Mupix10 Status and MuPix11 Preparation

Review Meeting date XXX

MuPix10 Powering

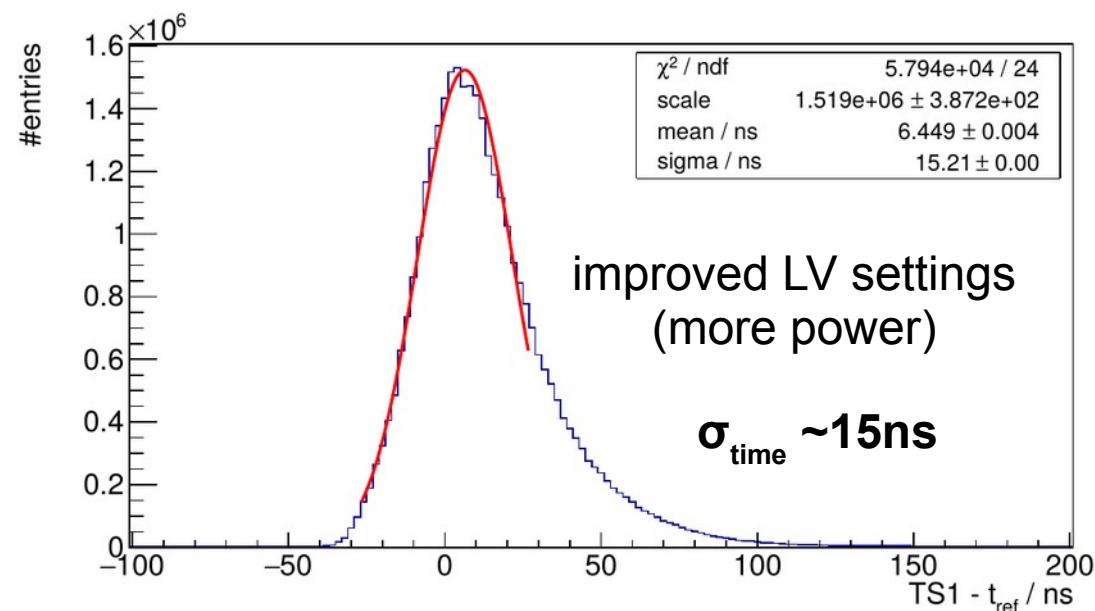
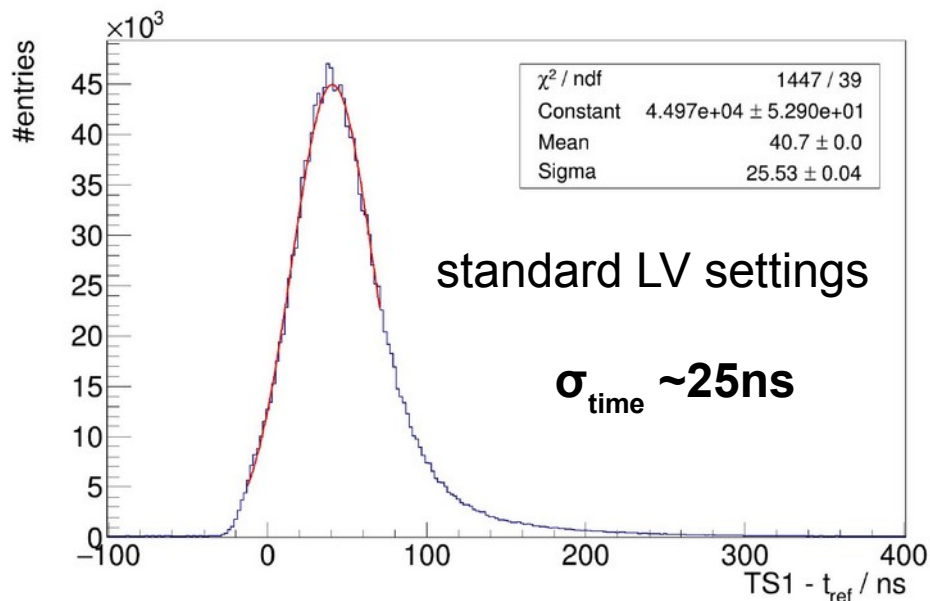
MuPix10 allows to measure back (analog) the voltage inside the chip:

Number of Connections	With add. Connections	Measured Resistance	Calculated Resistance	Resistance with add. lines	Measured voltage drop	Expected voltage drop	
nominal	1.8V	vdd	8	8+8	0.3Ω	0.26Ω	~0.13Ω	50mV	~25mV
	0V	gnd	4	4+8	0.4Ω	0.33Ω	~0.11Ω	60mV	~20mV
	1.8V	vdda	10	10+16	0.9Ω	0.75Ω	~0.37Ω	160mV	~60mV
	0V	gnda	11	11+10	0.6Ω	0.36Ω	~0.19Ω	170mV	~90mV
	1.2V	vssa	8	8+6	1.0Ω	0.76Ω	~0.44Ω	130mV	~75mV

Culprit: Pad to Power-Bar Connection

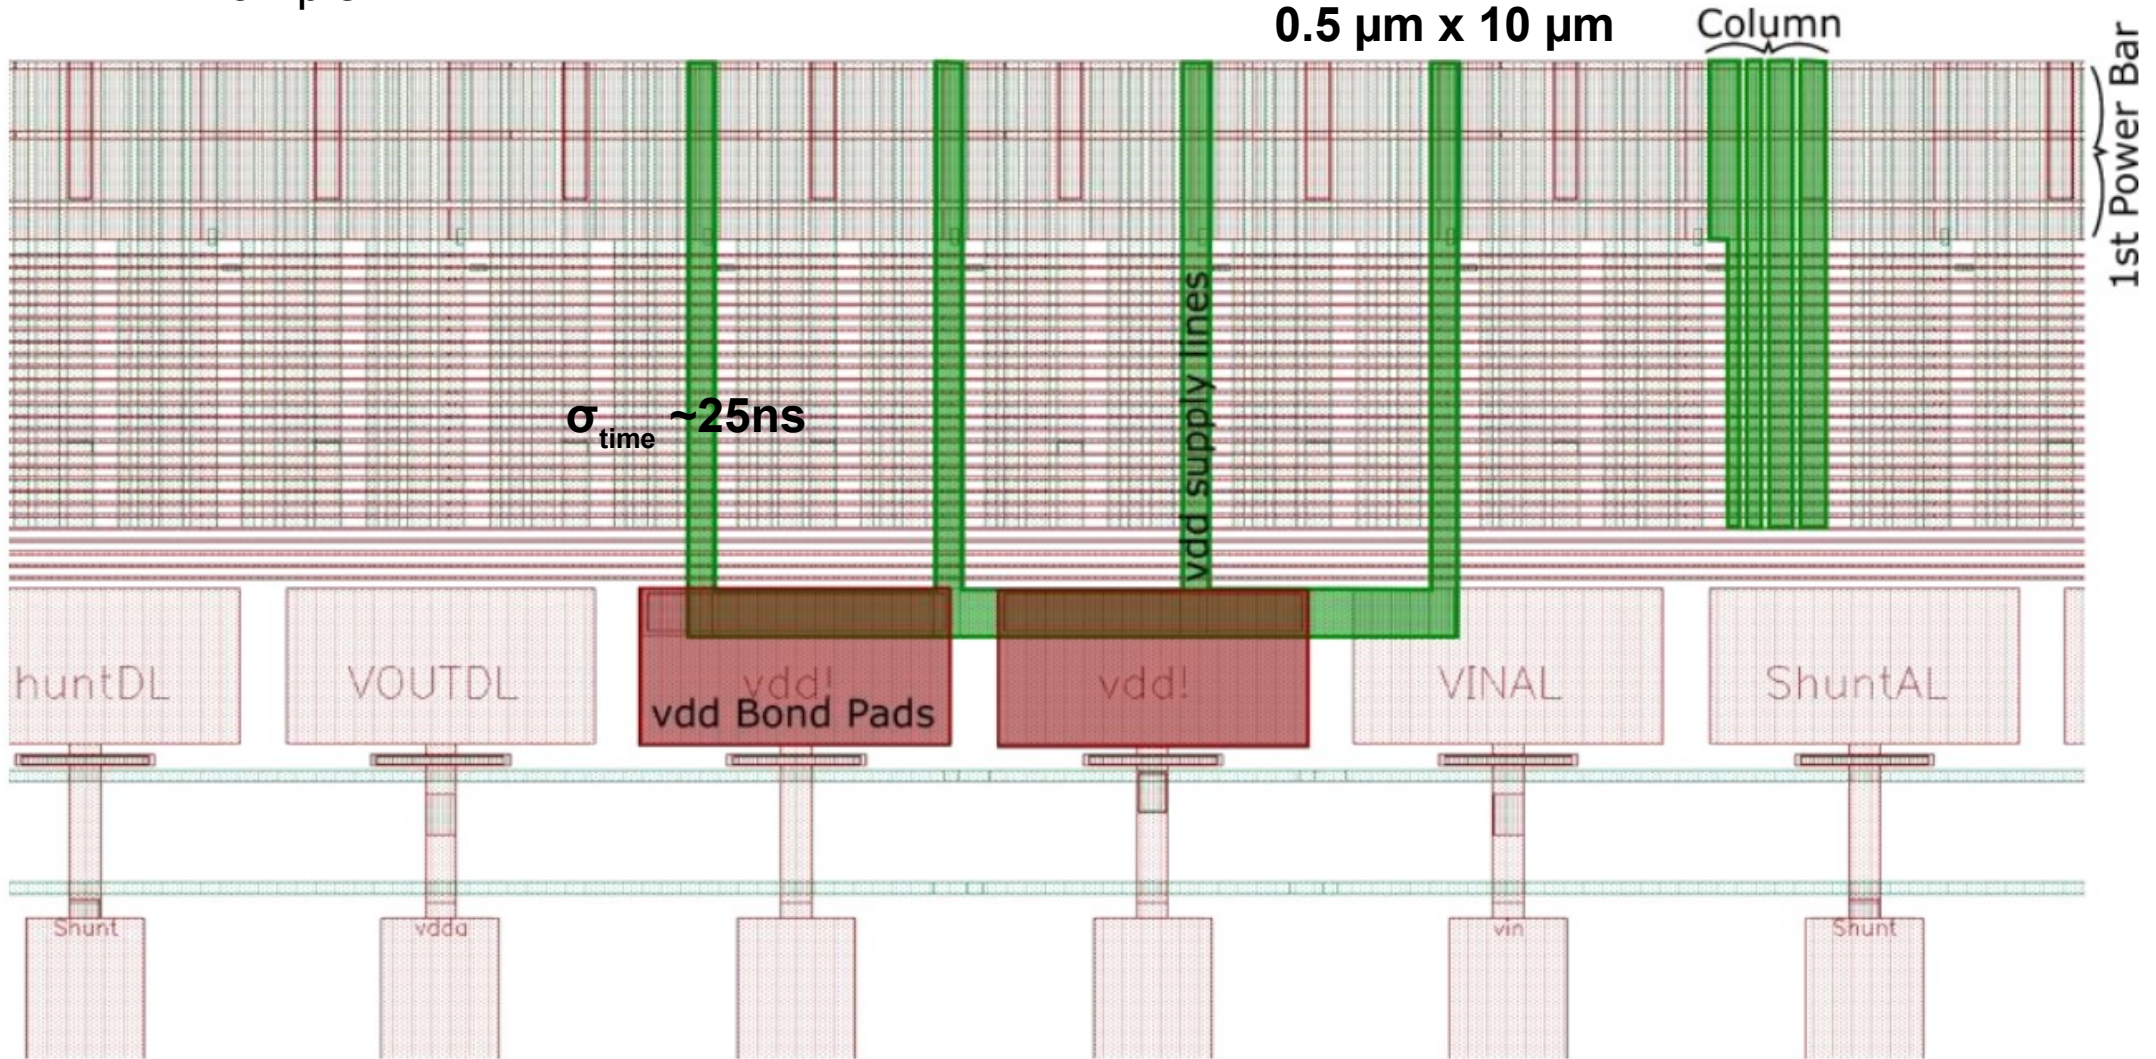
cross section
0.5 μm x 10 μm

Fix: Increase Connections

Possible to connect more supply lines

In addition, more metal layers are used

(similar for VDDA, VSSA, GND and GNDA)

The Low Signal Problem II

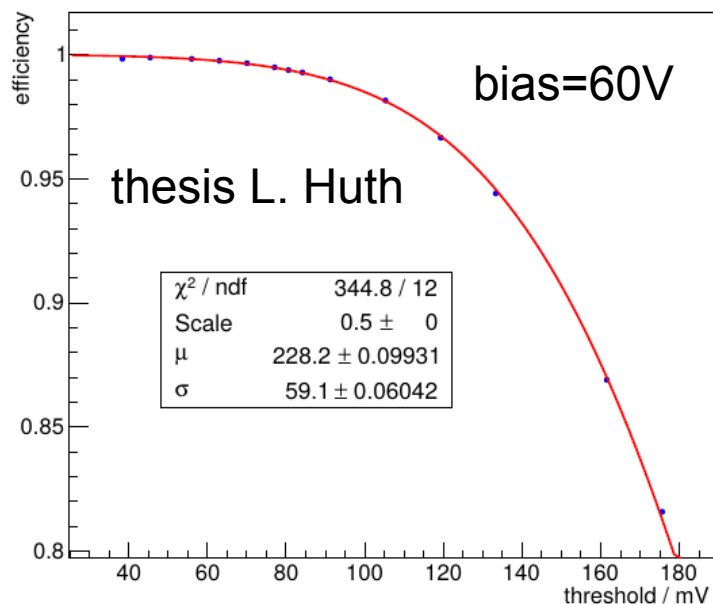
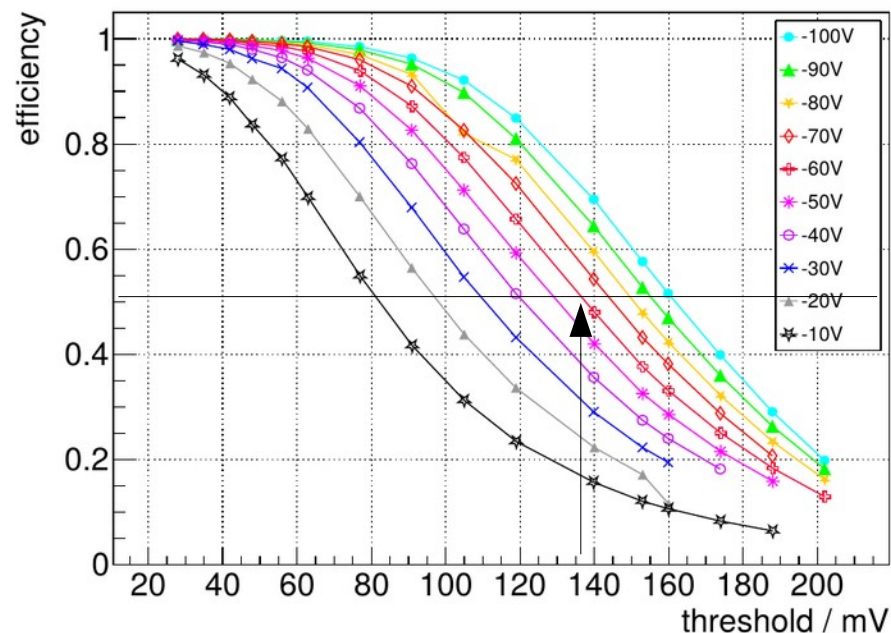
MuPix8 testbeam:
(100 um thickness, 200 Ohm cm)

50% efficiency at **229mV**

MuPix10 testbeam:
100 um thickness, 200 Ohm cm)

50% efficiency at **137 mV (56%)**

Signal is much smaller (56%) than expected from Mupix8

Amplifier and comparator basically unchanged from MuPix:

- AC coupling between source follower and comparator was slightly changed (50%)
- Capacity of baseline restoration transistor was changed

(both changes are expected to have minimal effects on performance)

Comparison Old vs. New Settings

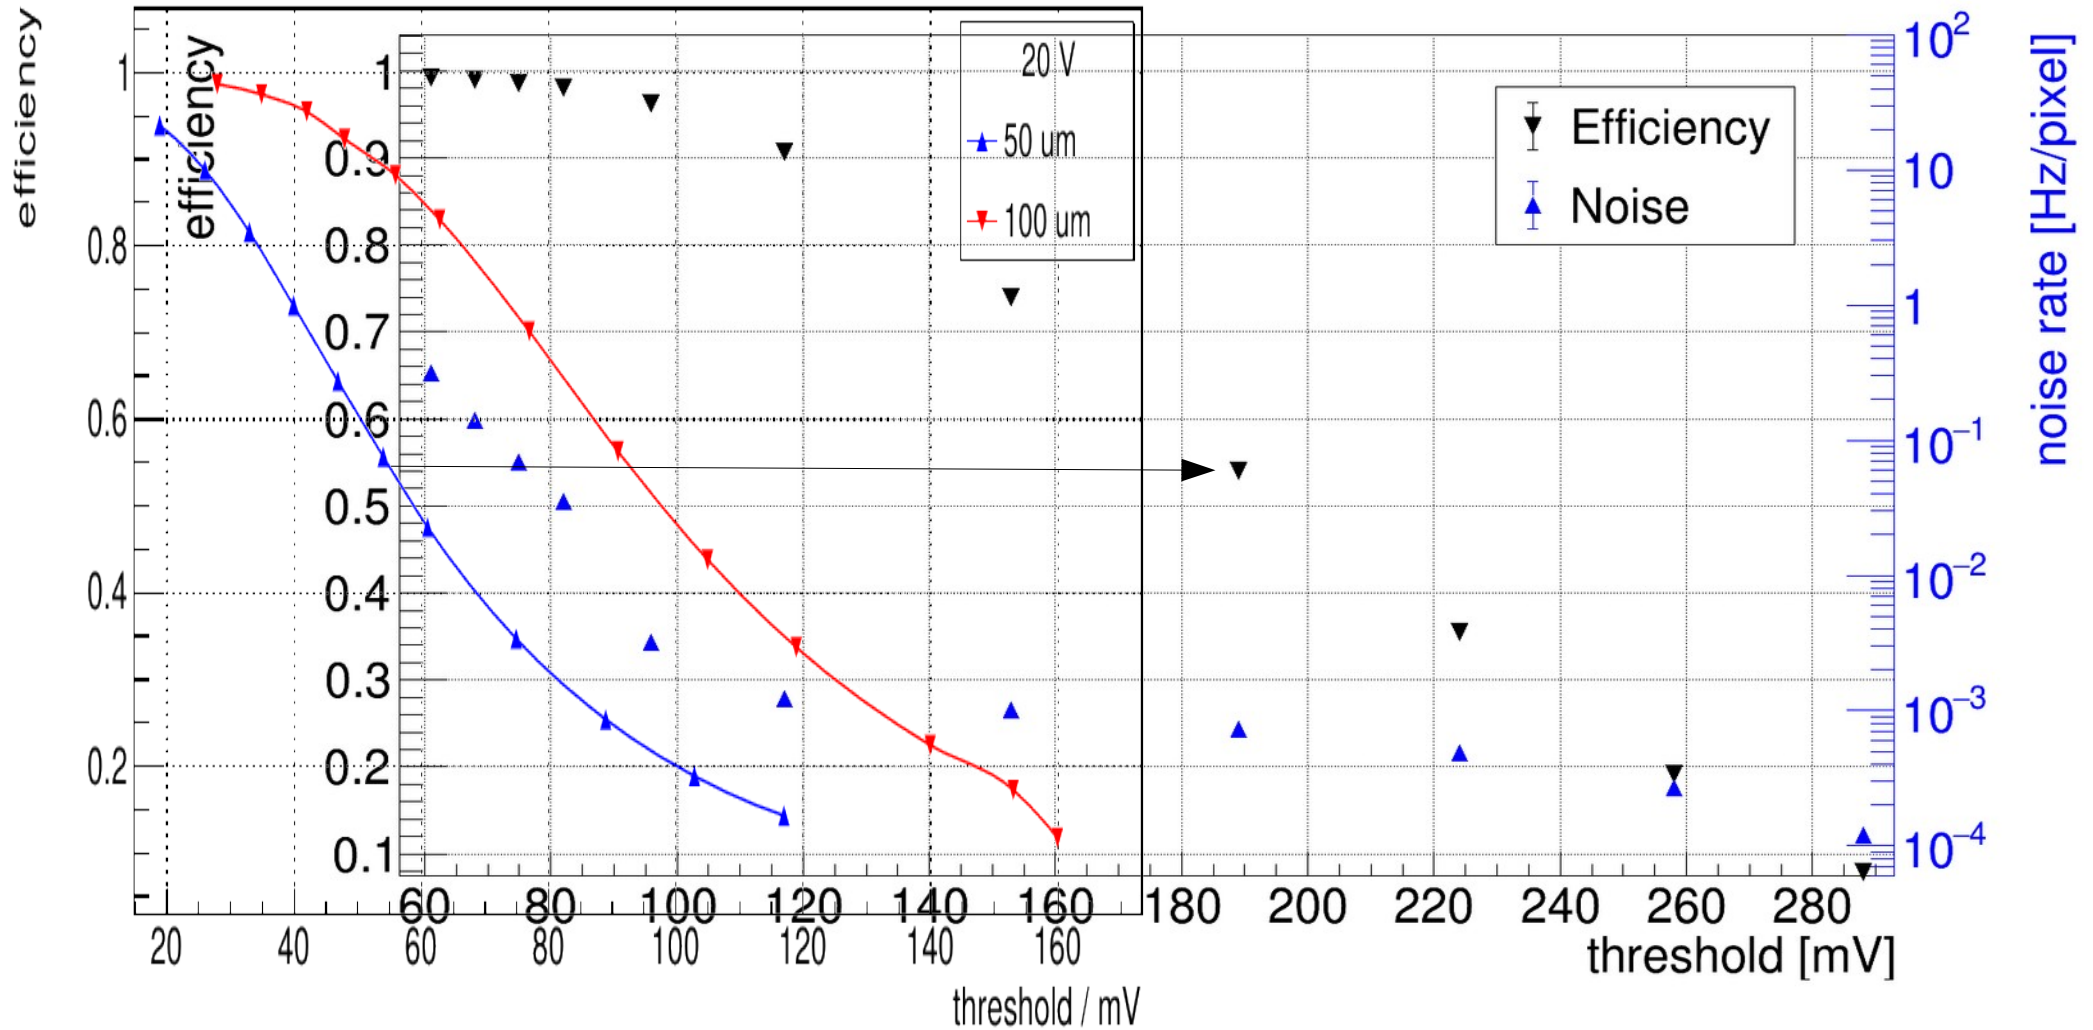
**COULD WE HAVE
CONSISTENT
PLOTS?**

- the signal is substantially larger with the new settings!
- issue is solved and understood!

Dynamical range of VPDAC (pixel tuning)

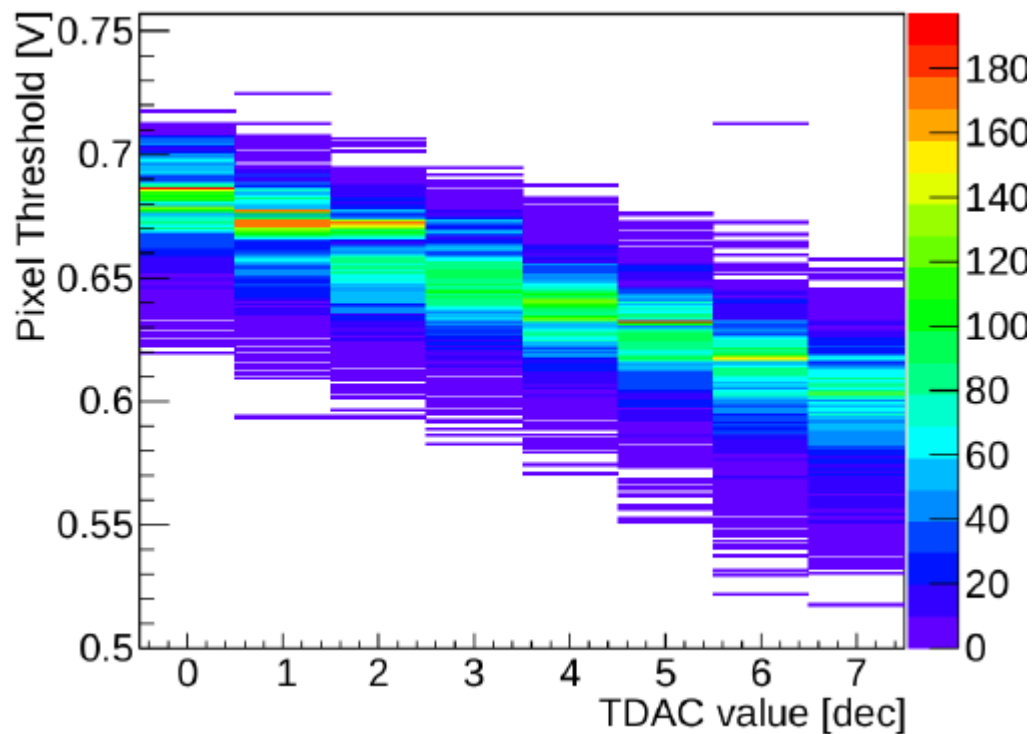
The adjustable range is a bit too narrow

HEIKO, ADD COMMENT

Dynamical range of delay circuitry

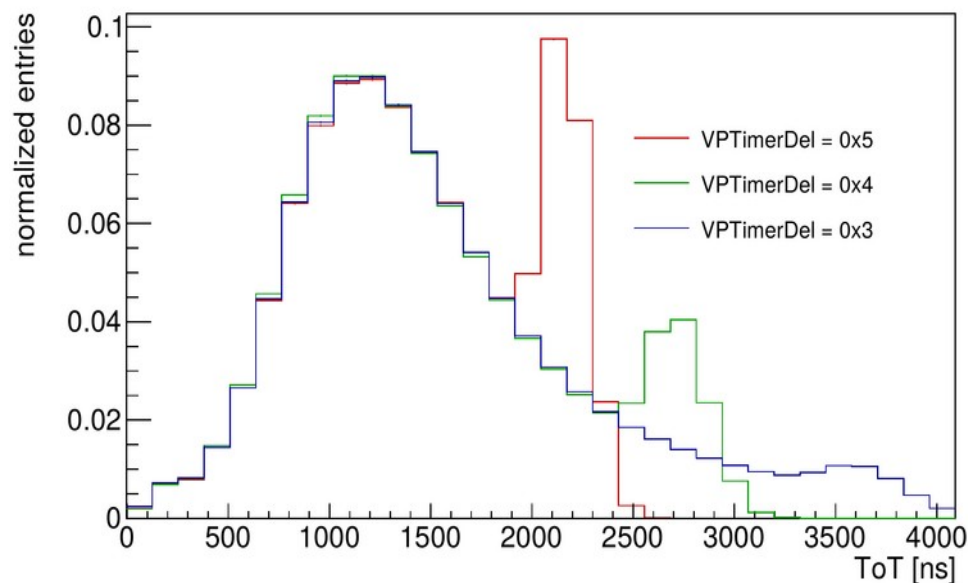
correct?

The full range (MSB) can essentially not be used

AS: I think the real problem is that the pulses are too long!

Baseline Restoration

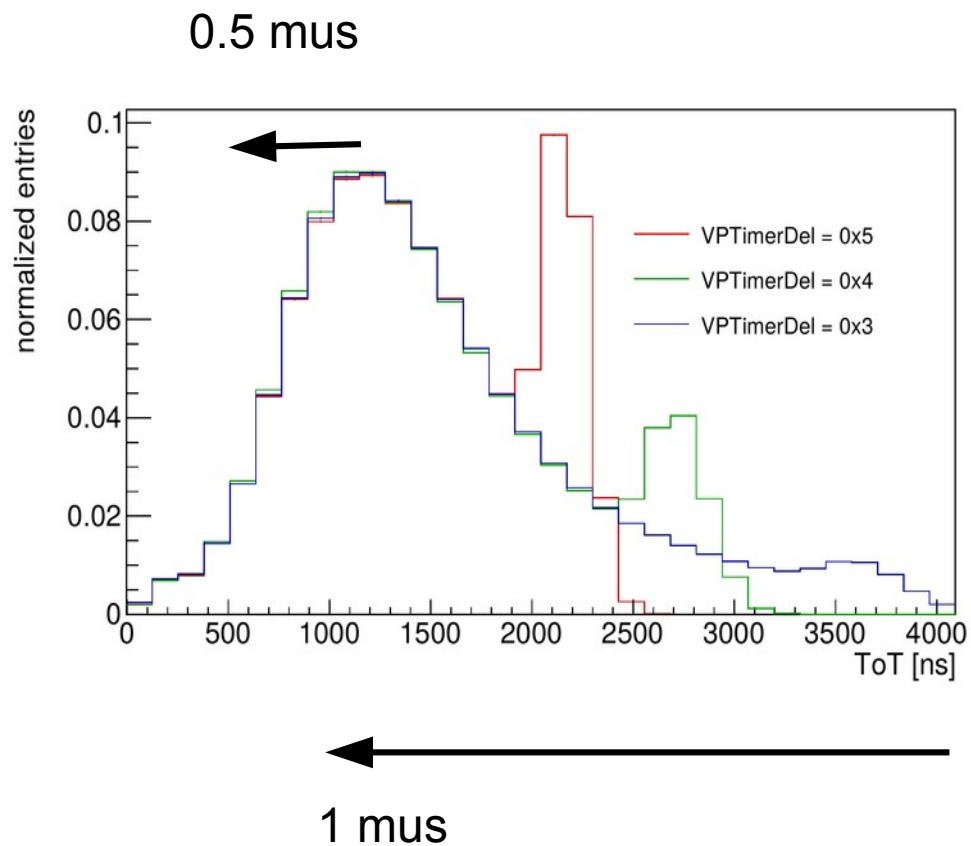
Baseline restoration should be speed up by a factor 2-4

COMMENTS!

ADD SCHEMATICS
